**BOROONDARA PLANNING SCHEME
AMENDMENT C69**

PANEL REPORT

MAY 2010

MAP 1: WEST HAWTHORN AREA AND PRECINCTS

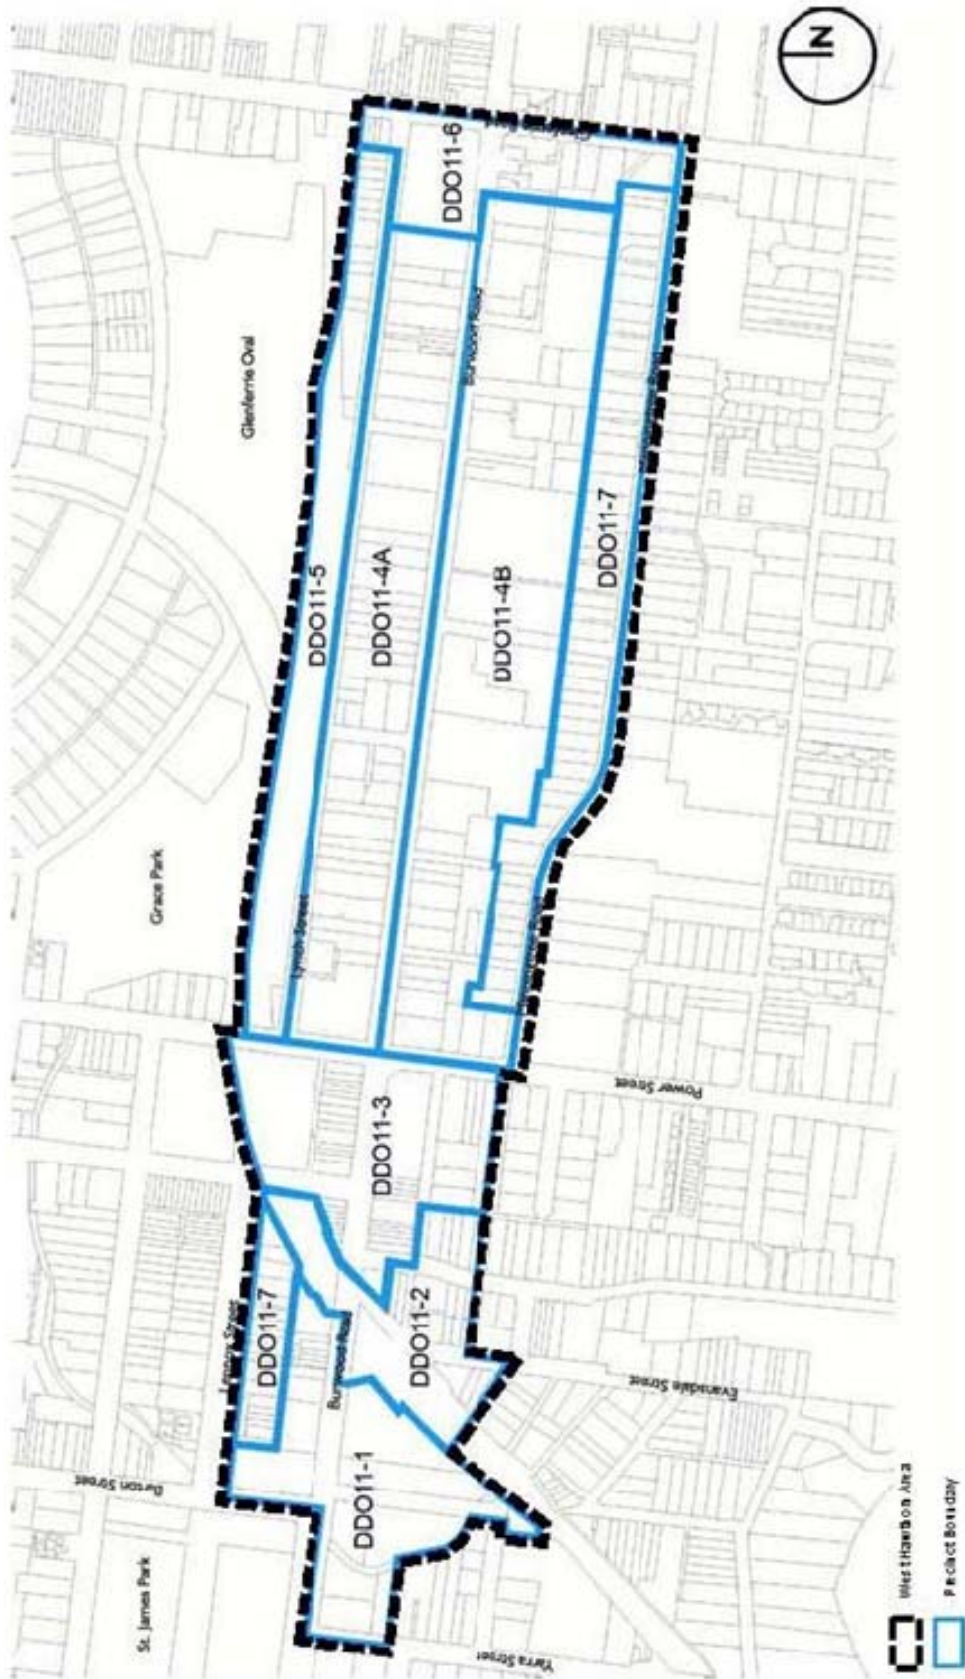
Delete Precincts 2 & 7

MAP 1: WEST HAWTHORN AREA AND PRECINCTS

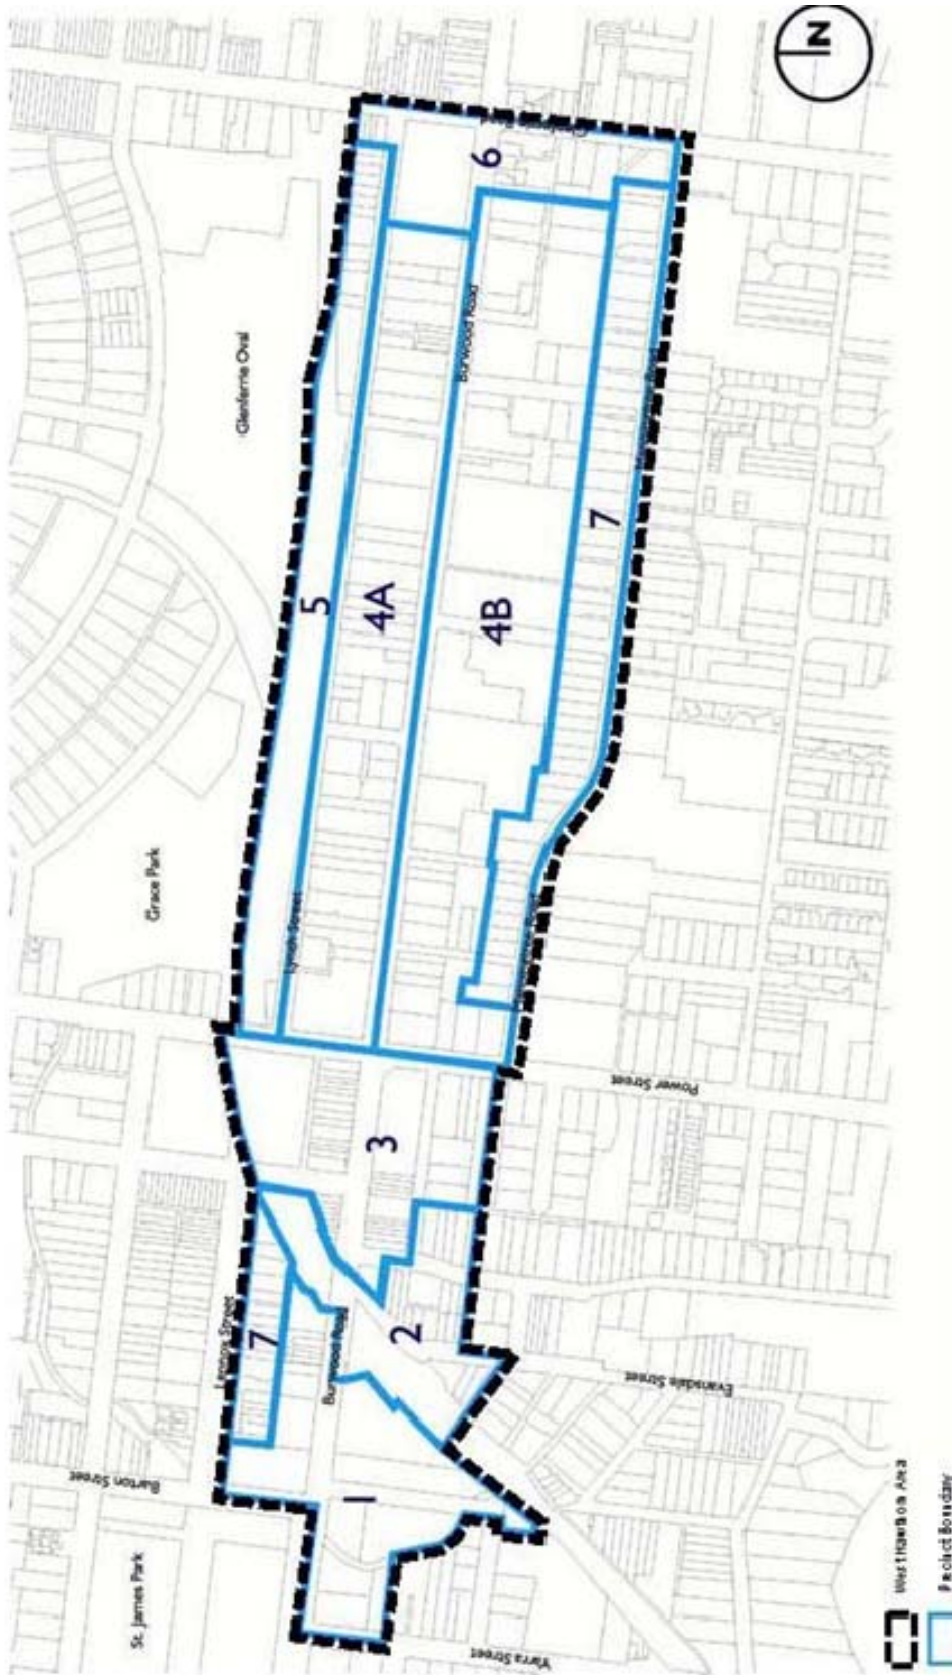
Delete Precincts 2 & 7

MAP 1: WEST HAWTHORN AREA AND PRECINCTS

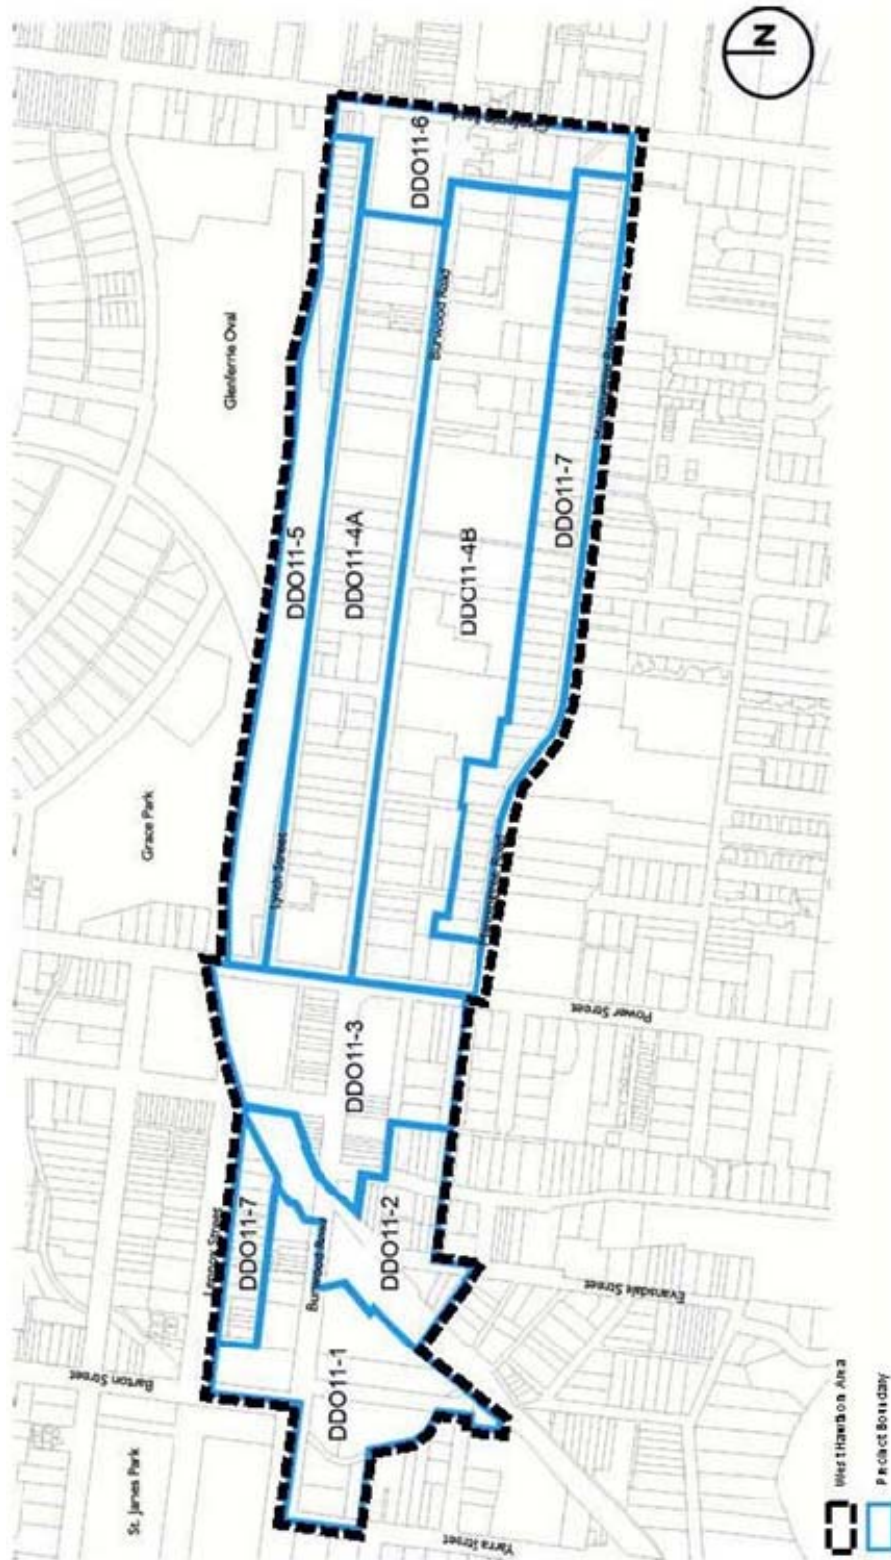
Delete Precincts 2 & 7
